**Planning Commission Meeting**  
**Wednesday, July 19, 2017 at 6:00 p.m.**

**TO:** Planning Commission  
**FROM:** Jerry Haddix, Village Administrator  
**RE:** Case 17-07P, Site Plan Review for Primrose School of South Lebanon  
**DATE:** July 17, 2017

Primrose School Site Plan  
Review #1  
Village of South Lebanon, OH

**SITE PLAN**  
**PRIMROSE SCHOOL**  
**OF SOUTH LEBANON**  
719 CORMAN-NIXON BLVD  
VILLAGE OF SOUTH LEBANON  
WARREN COUNTY, OHIO 45065  
SECTION 2, TOWN 4, RANGE 3

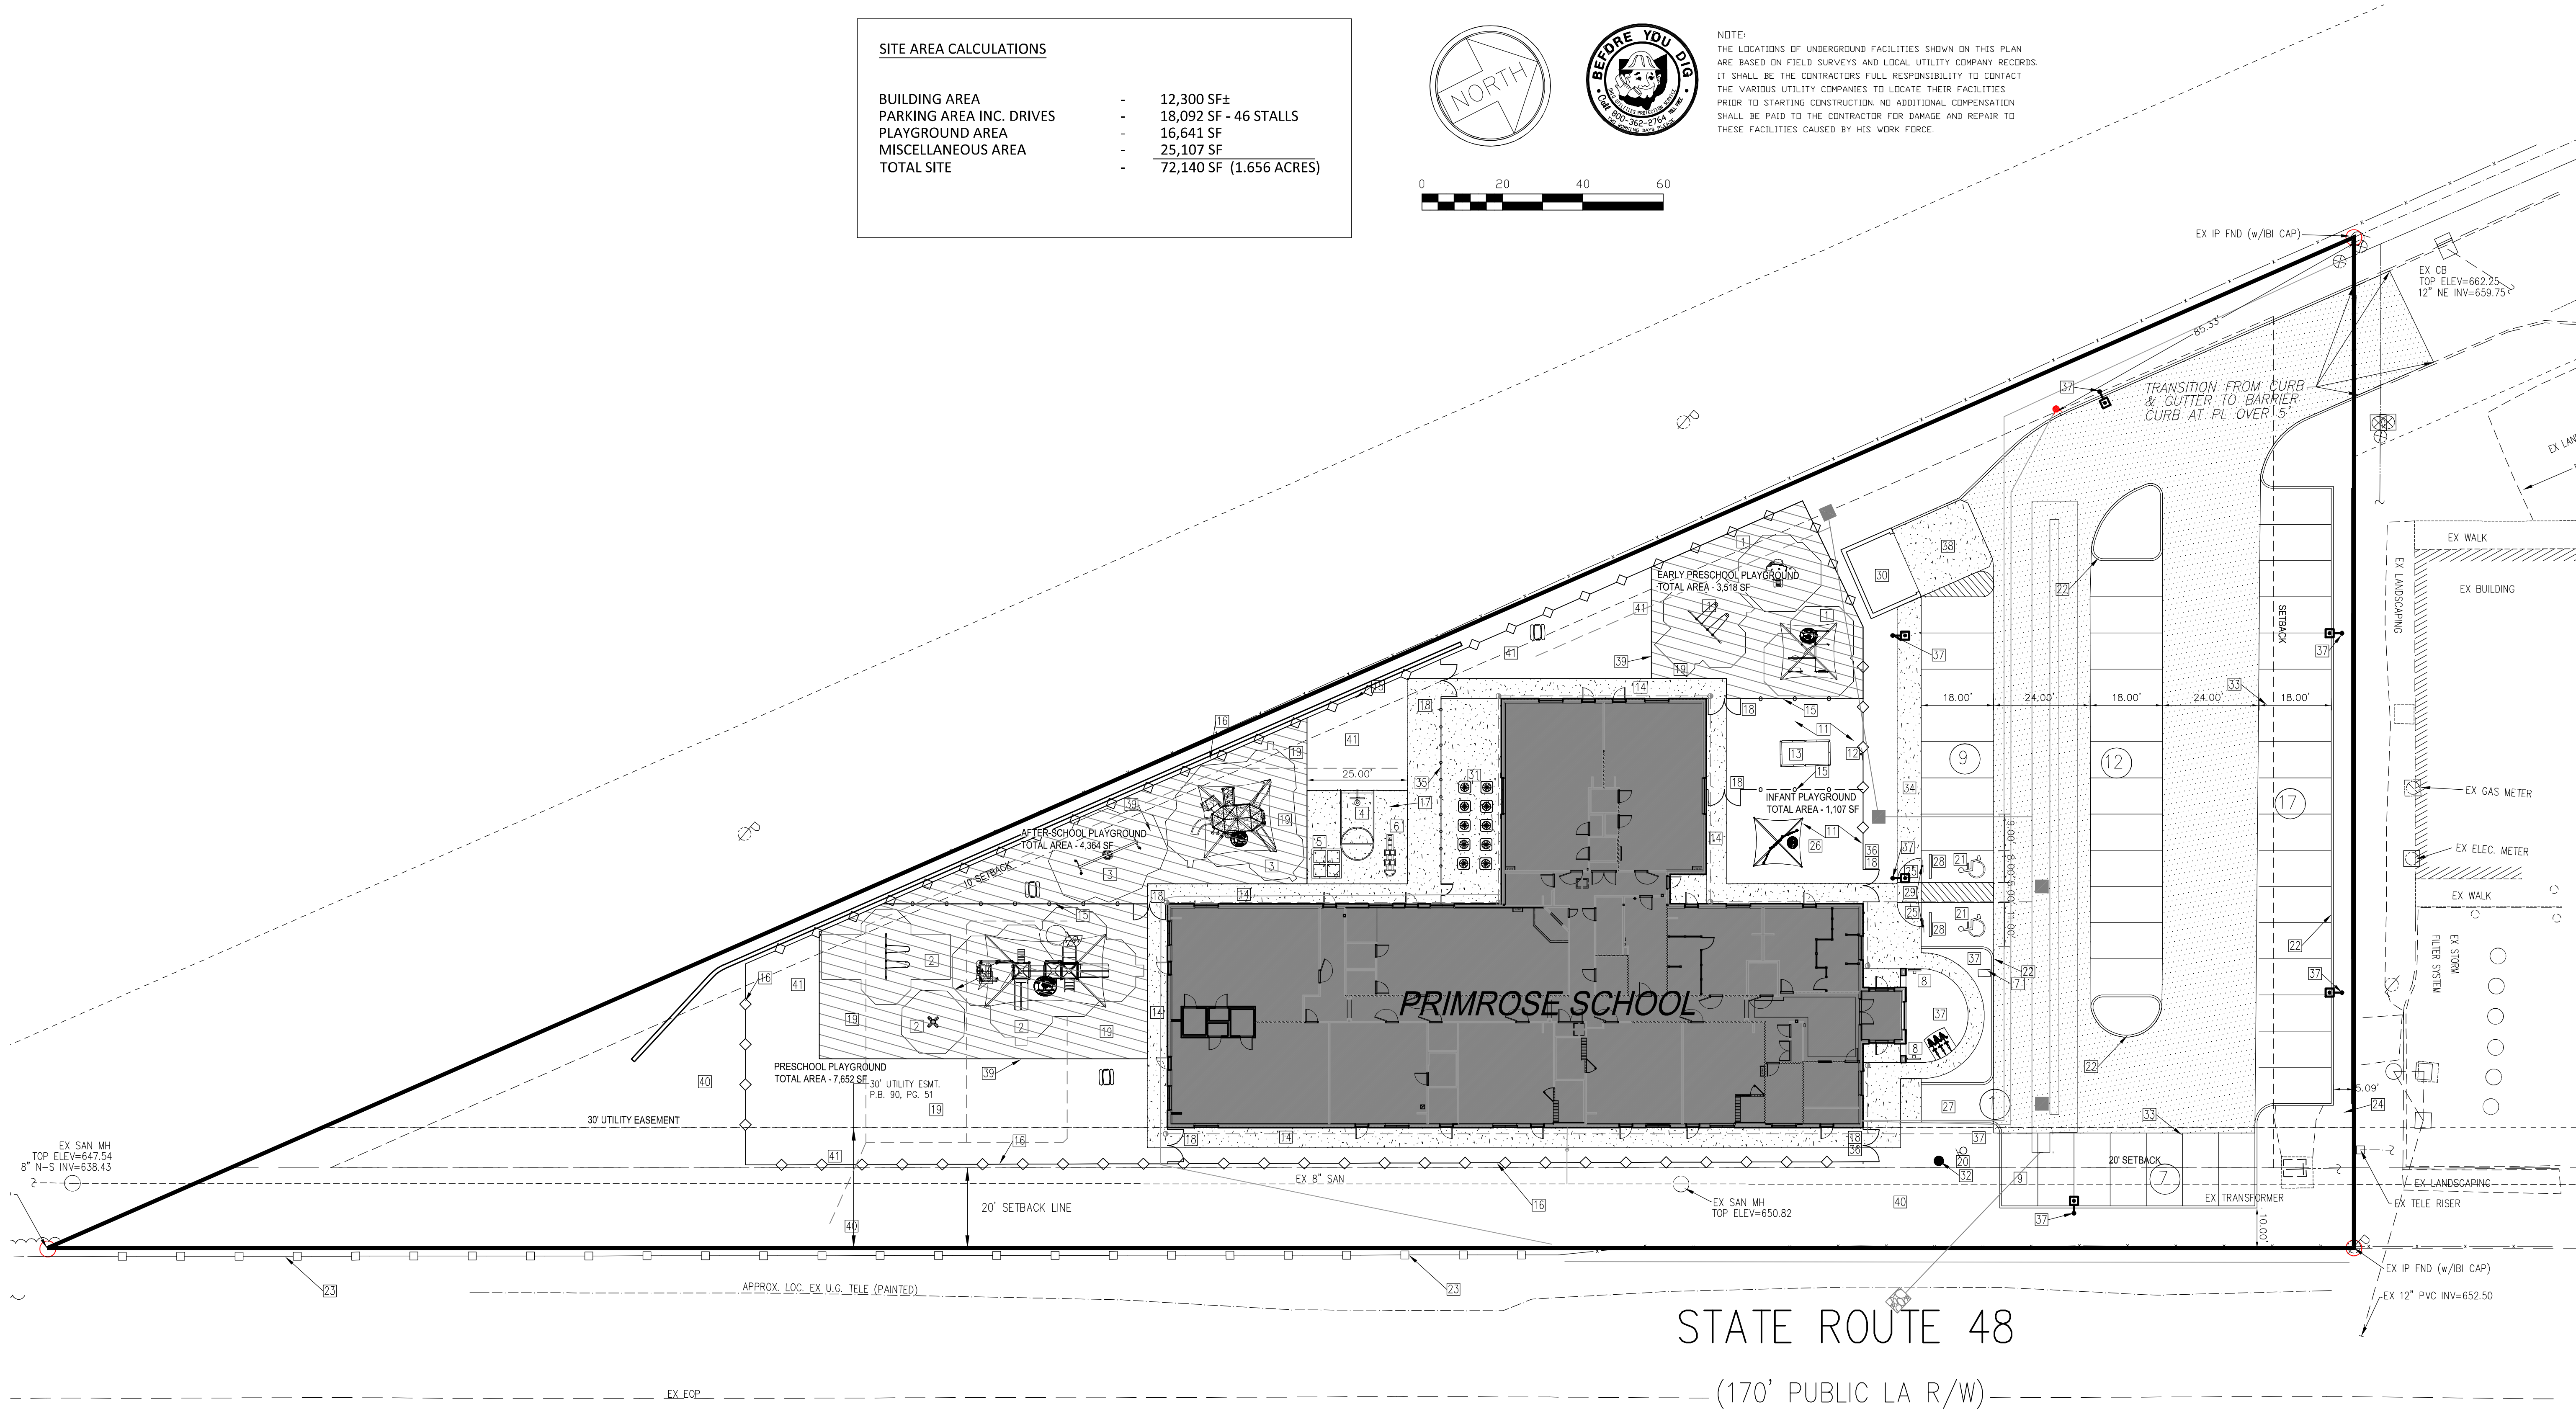
- Add new hatch to legend that explains what the diagonal playground hatch indicates
- Typo in site notes note #4.
- The building foundation appears to stick into the 30' utility easement. Is it possible to shift the building to the north, even if it is only 6"?

UTILITY PLAN

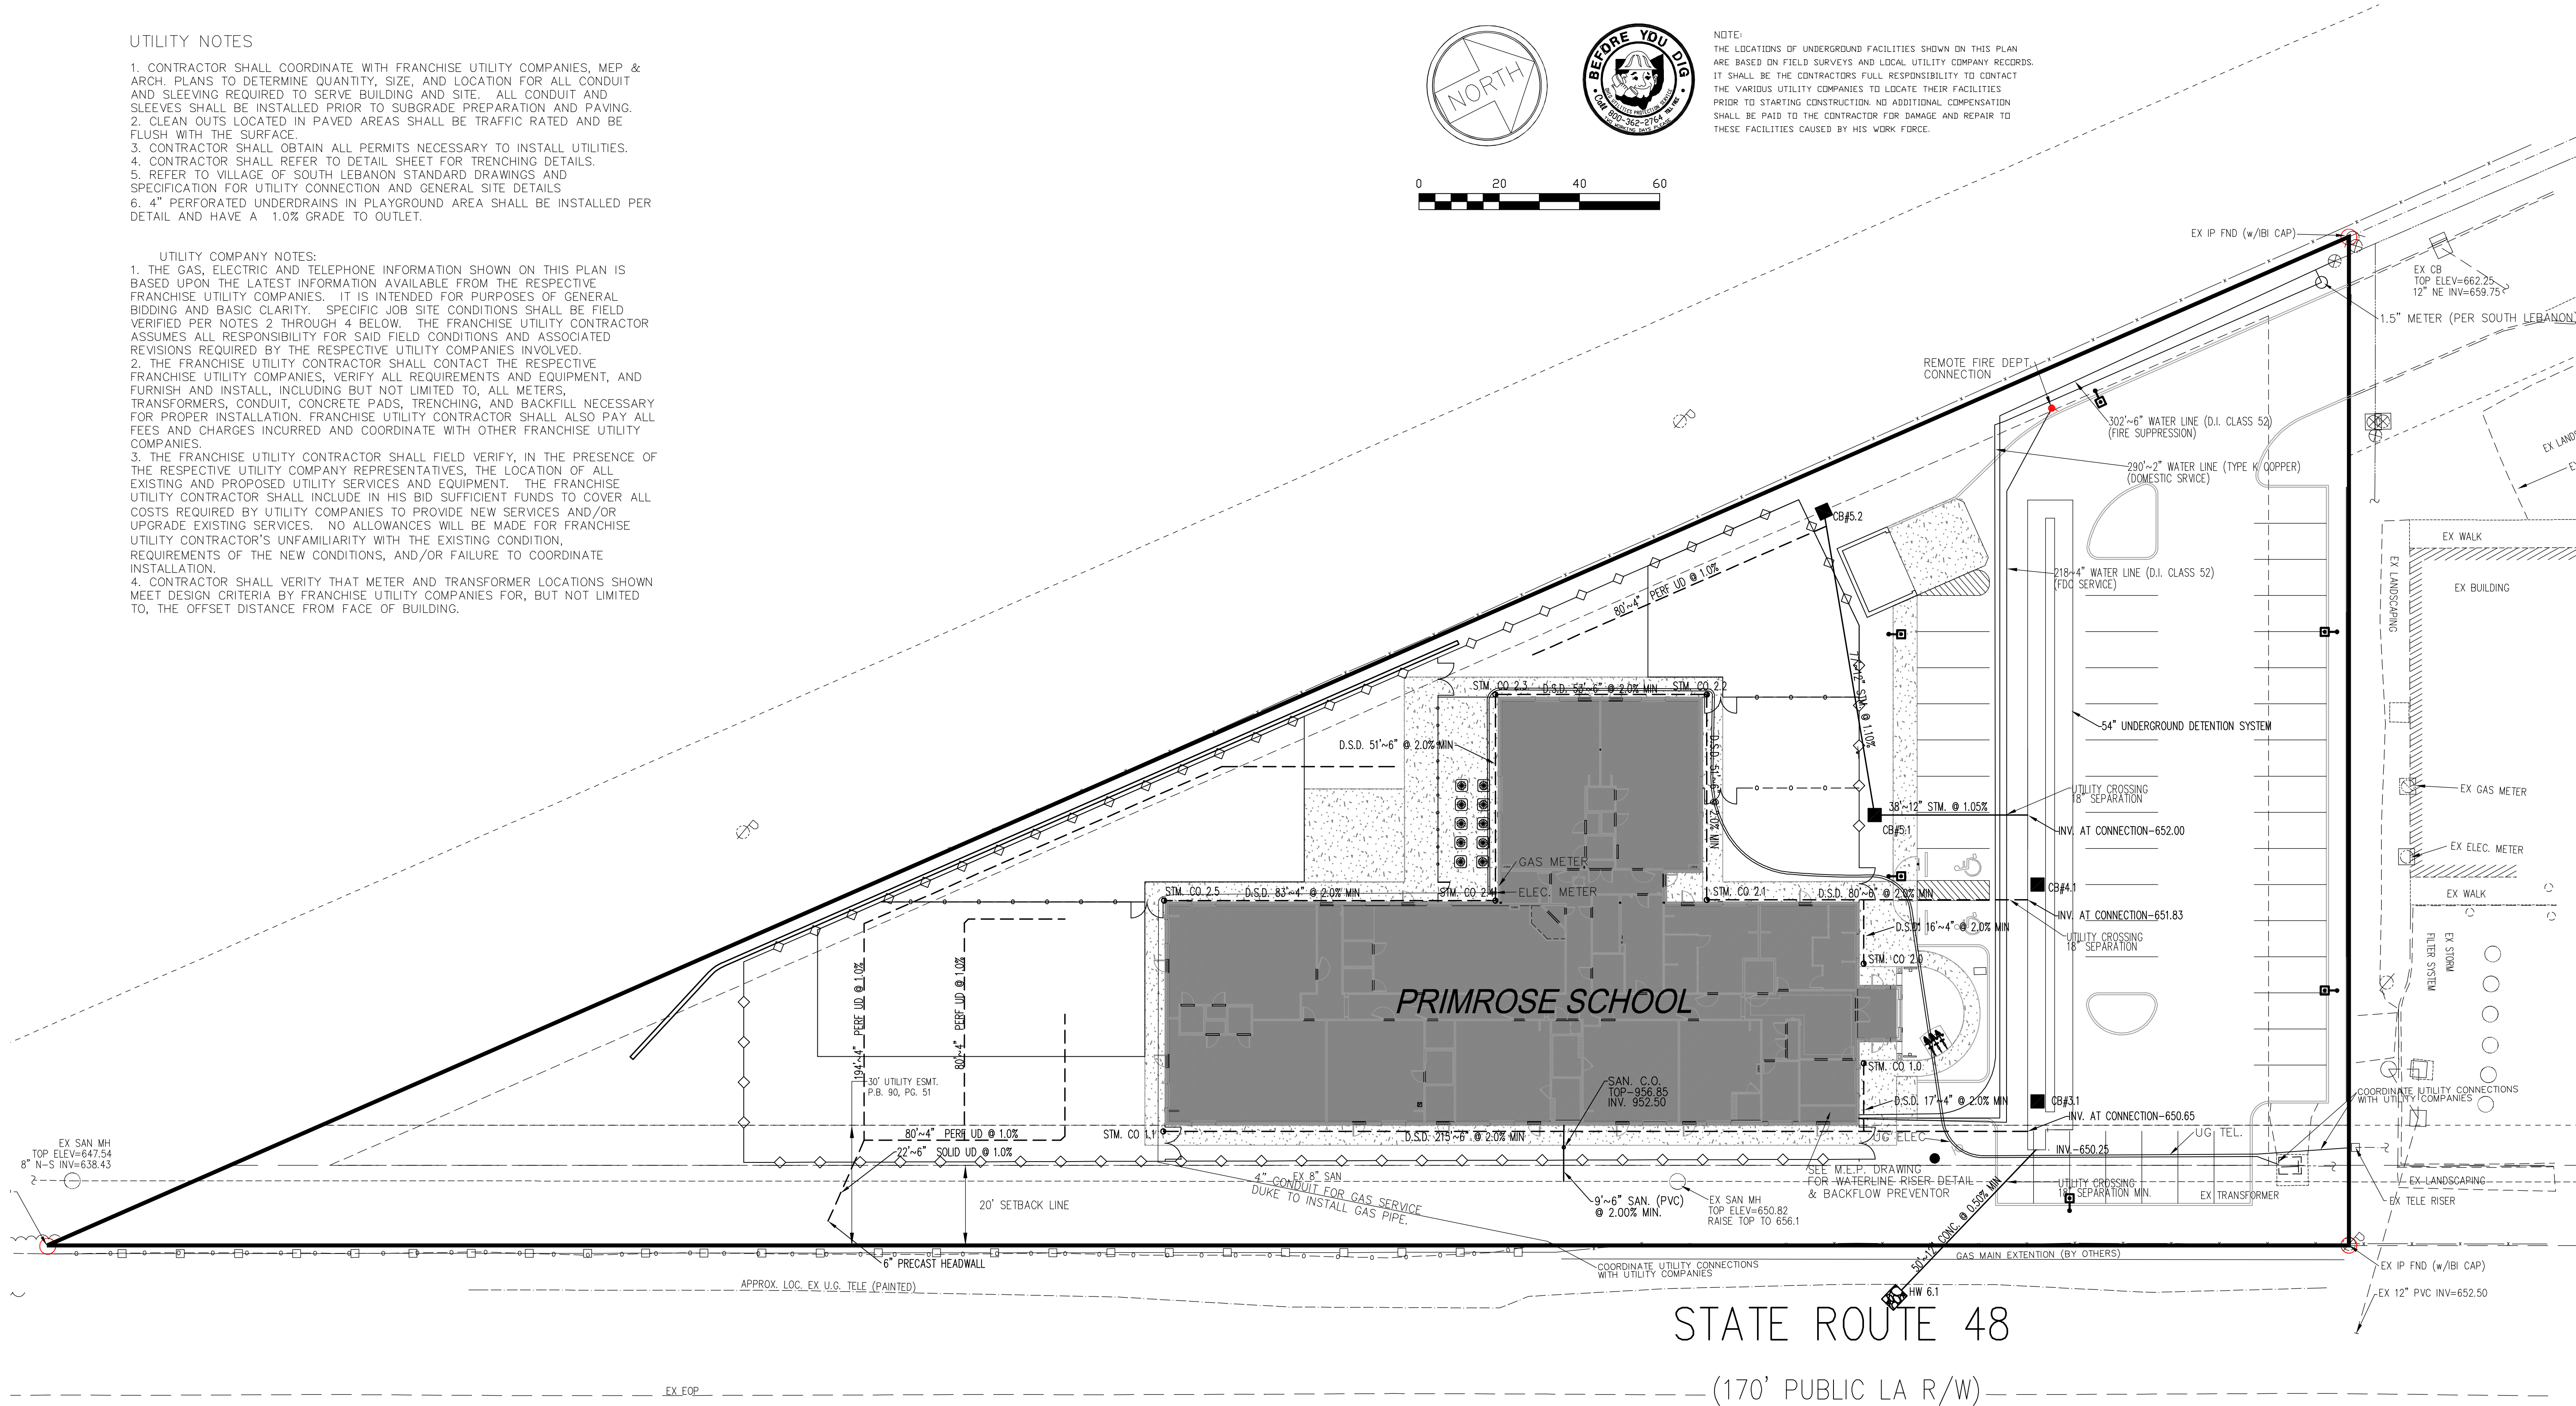
- Label invert of detention outlet on utility plan.

**GRADING PLAN**  
**PRIMROSE SCHOOL**  
**OF SOUTH LEBANON**

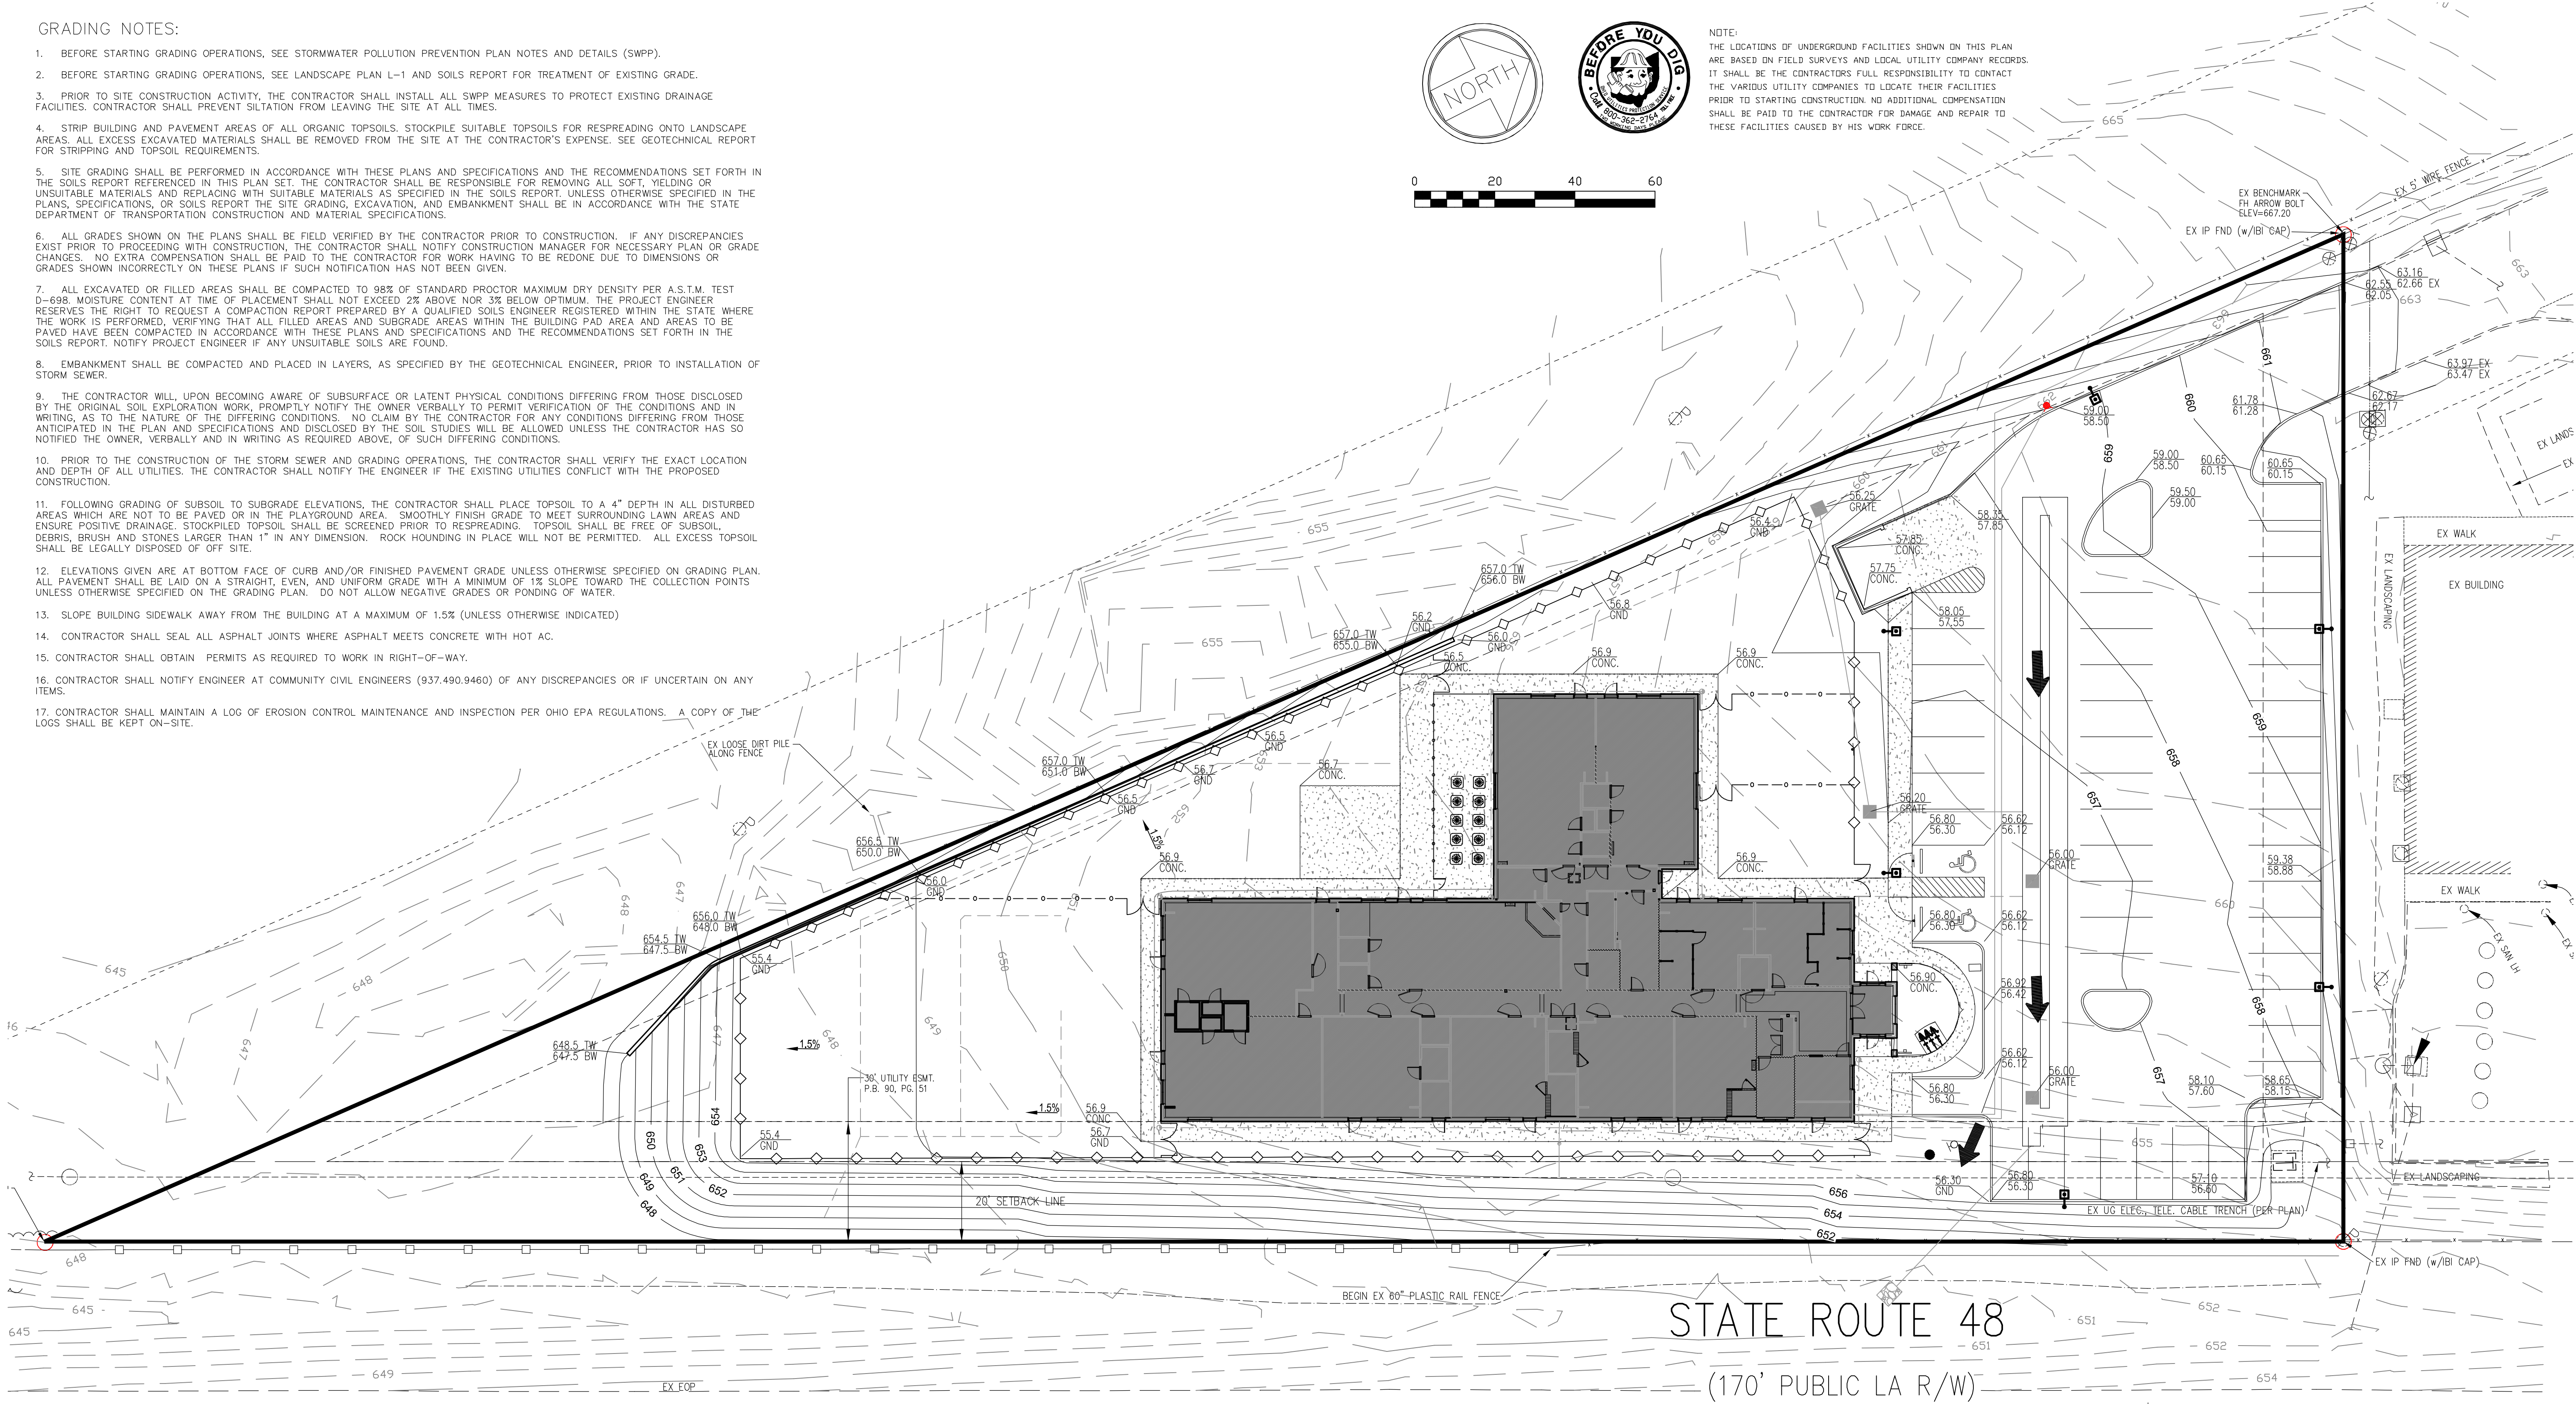
- Label finished floor elevation of the building on the grading plan.
